PLANNING COMMISSION MEETING STAFF REPORT

DATE OF MEETING:	February 21, 2018
NAME OF PROJECT:	Midway Springs
NAME OF APPLICANT:	Watts Enterprises
AGENDA ITEM:	Master Plan of Midway Springs
LOCATION OF ITEM:	600 North 200 East
ZONING DESIGNATION:	R-1-15

Berg Engineering, agent for Watts Enterprises, is requesting Master Plan approval of Midway Springs Subdivision. The proposal is a Planned Unit Development and standard subdivision that is 50.76 acres in size and will contain 96 units and one lot. The proposal is to develop the property in three phases. The property is located at 200 East 600 North and is in the R-1-15 zone.

PRELIMINARY SITE PLAN

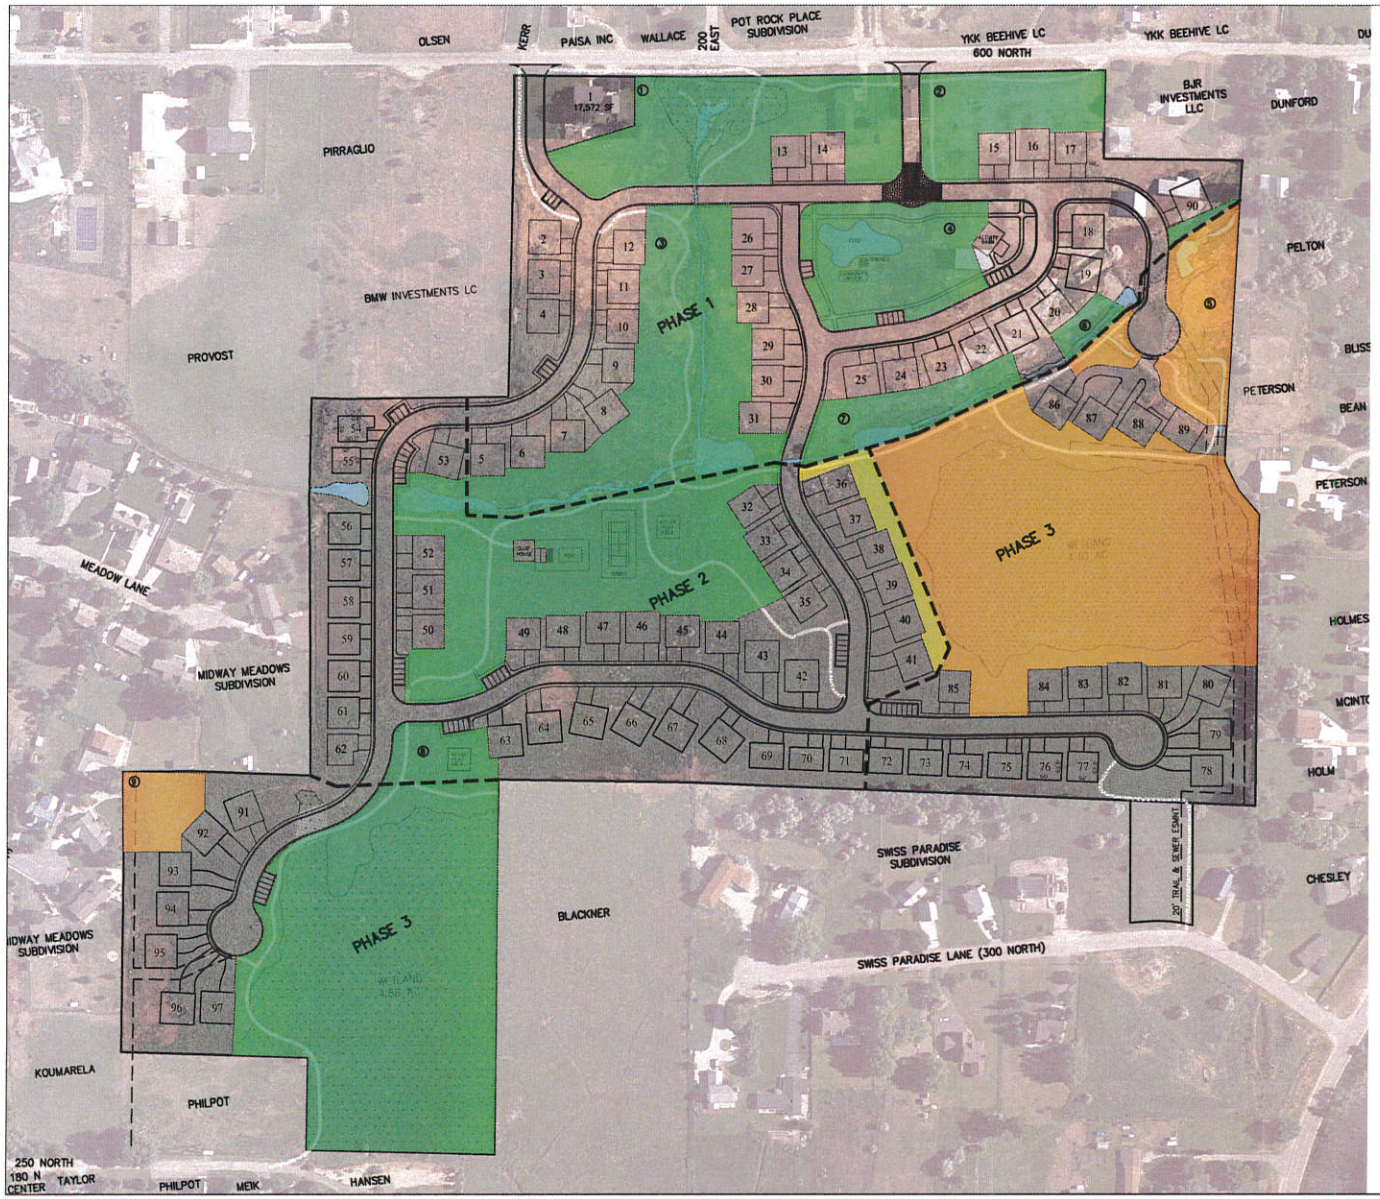
Open Space – The code requires that with each phase that is approved there is enough open space to comply with the requirements of the code. For example, phase I must have at least 50% open space for that particular phase. If phase I has 75% open space, then phase II only needs to have 25% open space if both phases are equal in acreage. The proposed plans do comply with the open space requirements.

Access – Each phase of the subdivision must meet the access and cul-de-sac limitation requirements of the code. A cul-de-sac is limited to 500' in length, unless approved otherwise by the City Council. Staff has reviewed the phasing plan and all street length and access requirements have been met as presented in the application.

Two Points of Access – The development plans have two points of access onto 600 North. The developer has attempted to access from three other locations that include 250 North, 300 North and River Road. All three options were unattainable. The two points of access on 600 North do meet the City requirements regarding the two points of access ordinance.

Sensitive Lands – The property does contain some wetlands that will not be disturbed through the development process. The wetlands will become part of the open space for the development and will be preserved. There is a stream/ditch that runs through the property. It will be impacted by the roads crossing the development because of the culverts that will cover the ditch. Midway Irrigation Company owns an easement to the ditch area and will need to approve modifications made to the current ditch. There is a warm spring on the property that will be preserved. There are also acres of wetlands on the property that are included in the open space areas of the development. A study has been submitted by the developer has been reviewed by three organizations that include The Army Corps of Engineers, Horrocks Engineers, and another third-party wetland expert that was decided by the City. There is concern by residents and of the area and the City regarding the location of wetlands and therefore the City has decided to have three entities review the study that has been submitted.

Staff is requesting a hydrology study is conducted on site to attempt to determine any potential impacts of development and develop solutions to those impacts if any are discovered. Residents that live in the surrounding areas of the development are concerned about several issues including the high-water table of the area and surrounding wetlands. The concern is that disturbance of high water table will have a detrimental consequence on the water table of surrounding properties. The City wants a hydrologist to study this issue and has worked with the developer regarding the study. Staff feels the location of roads and building pads should not be determined in phases 2 and 3 until the study has concluded.

1. No dirt or overburden be placed in the areas of phases 2 or 3 until those areas receive final approval except for in the designated park area. Any material placed in the designated park area must be graded within a week of being placed in the area.

2. A hydrology study is conducted on site and the areas of phases 2 and 3 are monitored to determine and potential impacts of disturbance of those areas. If any impacts are discovered, then a plan is presented to mitigate those impacts.

3. Location of infrastructure and building pads in phases 2 and 3 are not determined until the hydrology study has concluded and a wetlands delineation has been approved by the Army Corps of Engineers.

4. The linear park public trail is built, in its entirety, as part of phase 1.

PRELIMINARY
SITE PLAN

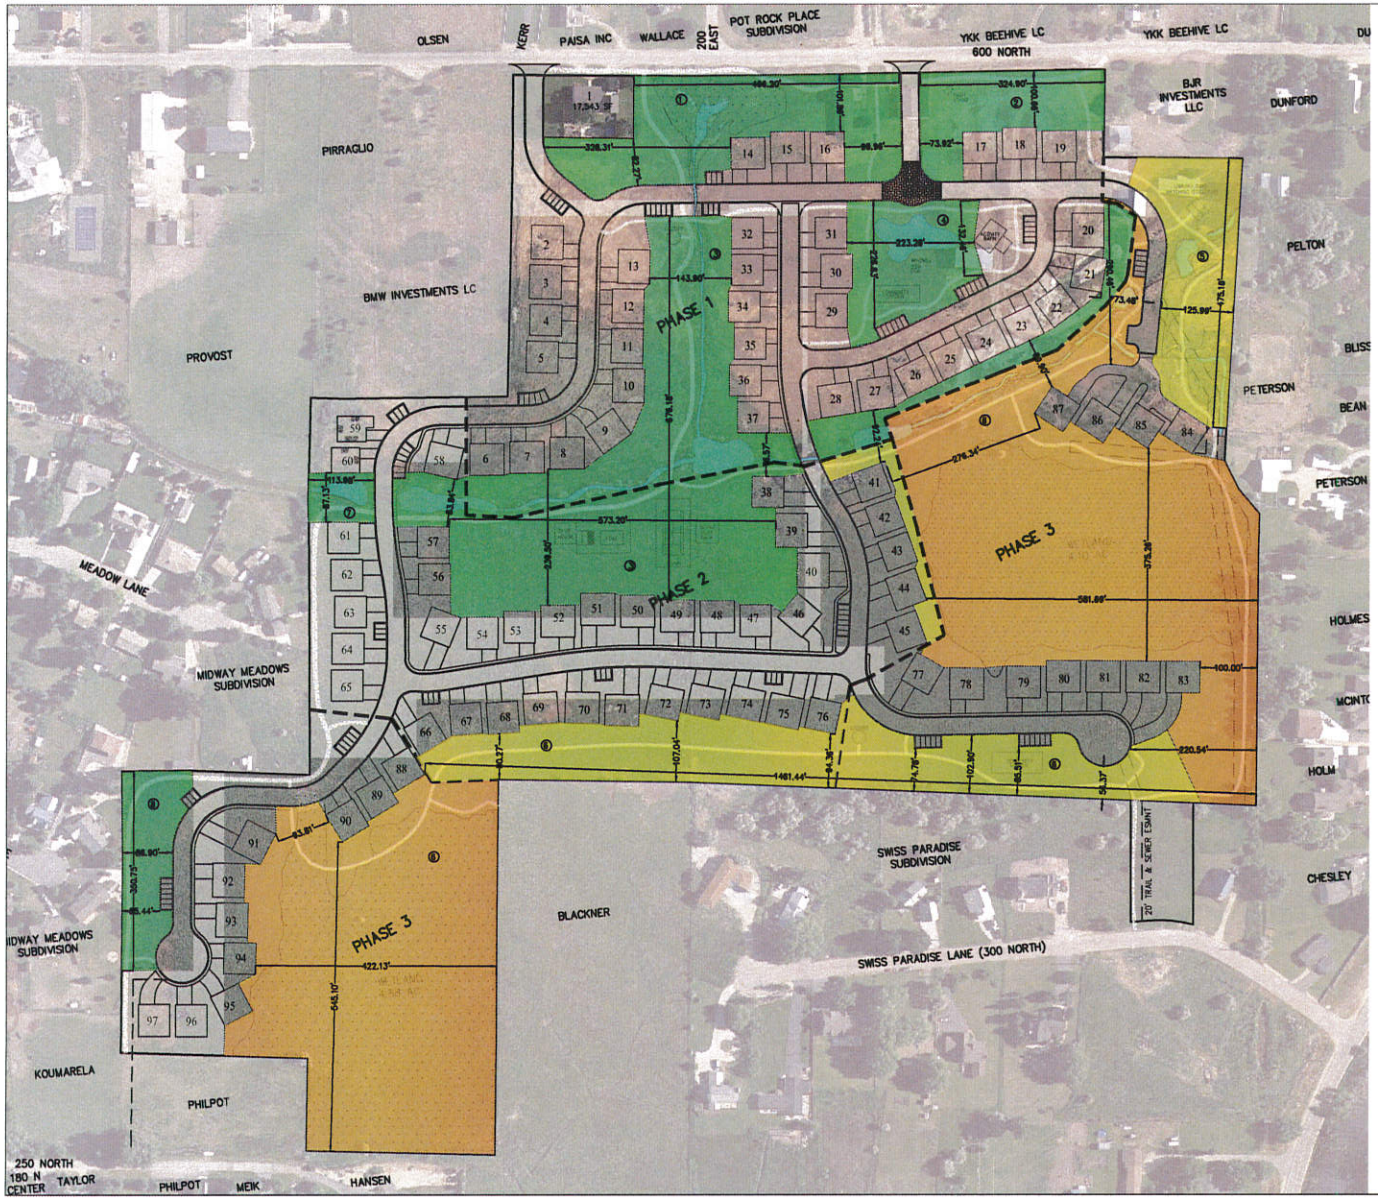
The developer has submitted an alternate option that repositions some of the building pads to create more space along the edges of the development. Also, trails have been placed along the edges of the proposal that will be more accessible to surrounding properties. The following is a list of changes that have been made and what will need to happen for options 2 to be approved.

- The units have been repositioned farther from the property lines. The City engineer has the ability to allow construction in the buffer zones of the wetlands, the wetland areas themselves will not be encroached upon.

- The south-western cul-de-sac has been reversed so the units now back up to the wetlands. This cul-de-sac measures greater than 500' which means the City Council will nee to specifically approve the extended length.

- The south-eastern cul-de-sac has been shortened to leave more open space.
- The north-eastern cul-de-sac has been removed and been replaced by a hammerhead turnaround that takes up less space.

- The trails have been repositioned to run along the eastern and western boundaries instead of the original location in the center of the property.
- Open space has been positioned around the periphery of the project. This will only be an option if the land use code is amended to allow areas less than 100' in width to count as open space. This code text amendment is currently under review by the City Council.

- Landscaping has been placed strategically to attempt to shield light pollution from vehicles in the development from shining onto neighboring properties.
